UNITED STATES DEPARTMENT OF COMMERCE United States Patent and Trademark Office Address: COMMISSIONER FOR PATENTS P.O. Box 1450 Alexandria, Virginia 22313-1450 www.usplo.gov

APPLICATION NO.	FIL	NG DATE	FIRST NAMED INVENTOR	ATTORNEY DOCKET NO.	CONFIRMATION NO.	
10/781,175	02	/18/2004	Michael R. Oldenburg	6919.03	1818	
29293	7590 07/17/2006		EXAMINER			
FREUDENE	BERG-NC	K GENERAL P	PATEL, VISHAL A			
LEGAL DEP	ARTMEN	T				
47690 EAST	ANCHOR	COURT		ART UNIT	PAPER NUMBER	
PLYMOUTH, MI 48170-2455				3673	· · · · · · · · · · · · · · · · · · ·

DETAILED ACTION

FIG. 1

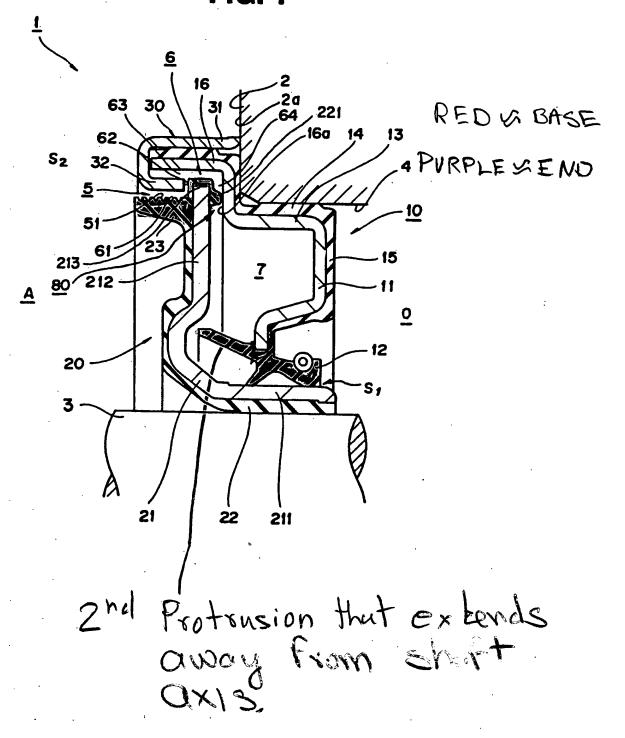
Regarding claim 1: Heinzeh figure 1 (see attached figure 1), discloses a seal for sealing a shaft, the seal comprising a sleeve constructed to be disposed generally coaxially around the shaft (sleeve 211) and comprising a parallel sleeve portion (sleeve portion that contacts the shaft 3) that is generally parallel to the longitudinal axis of the shaft and a radially extending sleeve portion (portion having 212) that extends generally radially away from the longitudinal axis of the shaft, an outer housing (housing that surrounds the sleeve) configured to generally surround the sleeve and comprising a parallel housing portion (portion 16) that is generally parallel to the longitudinal axis of the shaft, a radially extending housing portion (below 11 that has a base of a protrusion) that extends generally radially towards the longitudinal axis of the shaft, and a faceplate portion (portion between 16 and 13 and having surface 16a) that extends generally radially towards the longitudinal axis of the shaft, a first elastomeric protrusion (221 that has acute angle on surfaces that face the shaft and housing portion 16) extending between the radially extending sleeve portion and the faceplate portion and including a base (base of 221 that is in red in the attached figure 1) and an end (end that are indicated in purple in the attached

figure) generally opposite the base (end of 221) and oriented radially towards the longitudinal axis of the shaft (the end extends radially towards the longitudinal axis of the shaft) and a second elastomeric protrusion (see attached figure) including a base secured to the housing and an end generally opposite the base, wherein the end is oriented radially away from the longitudinal axis of the shaft. All the protrusions that are on the radially extending housing portion have a base that is adjacent to a distal end of the radially extending housing portion (see attached figure).

As shown in the attached figure 1 by red and purple markings the base and end of protrusions, respectively.

Regarding claim 20: The seal having a third elastomeric protrusion (protrusion above the distal end of 212 or 23) including a base secured to the radially extending sleeve portion and an end generally opposite the base, wherein the end is oriented both radially away from the longitudinal axis of the shaft and axially outwardly (see attached figure).

Regarding claims 22-23: The first elastomeric protrusion has an acute undercut angle (acure antle on both sides of 221).

Regarding claim 53: 1st protrusion that is 221, second protrusion that is at the distal end of 212 and third protrusion that is 23. All the protrusion are attached to the sleeve

FIG. 3

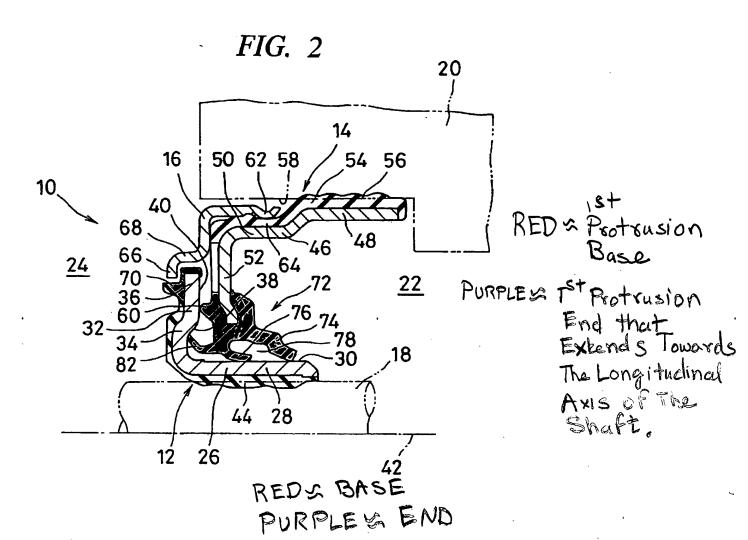
As shown in the attached figure 2 by red and purple markings, the first protrusion 70 has a base and an end, where the end is generally opposite the base, the end is oriented radially towards the longitudinal axis of the shaft and between the radially extending sleeve and the faceplate portion.

Applicants' argument against Ganda that the first protrusion is between the sleeve and the face plate is not persuasive because as shown in the attached figures the protrusion is between the face plate and the radial portion of the sleeve. Furthermore as shown in the figures the first protrusion is extending toward the longitudinal axis of the shaft (see attached figures).
